Technical News Bulletin

June 2008

Upgrade of Electro-pneumatic Valve Block - 26 Lines

Upgrade kit 210-495-01 for valve block front plate 210-384.

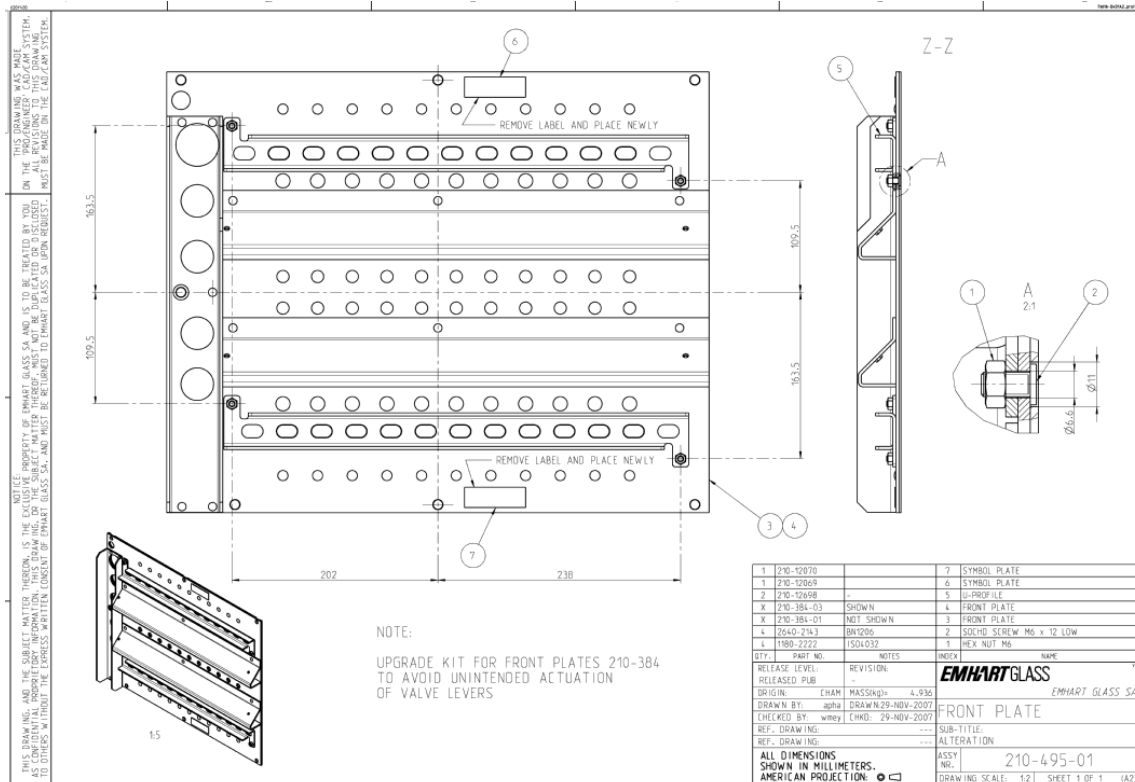
After the very successful introduction of the 26 line Electro-pneumatic Valve Block 210-444, an upgrade on Front Plate 210-384 is recommended to avoid unintended actuation of the valves.

The upgrade can be done by ordering at Emhart Glass, the required upgrade kit 210-495-01.

Emhart Glass supplies new 26 line front plates as shown on the attached drawing 210-495-01.

Instructions for U-Profile 210-12698 assembly:

1. Remove front cover
2. Mark (see dimensions on 210-495-01)
3. Drill 4 holes for the M6 mm *12 screw's for profile fixation
4. Remove about 12 mm from the gasket around the 4 holes
5. Assembly the two U-Profiles with index 13 and 14 on drawing 210-384-01
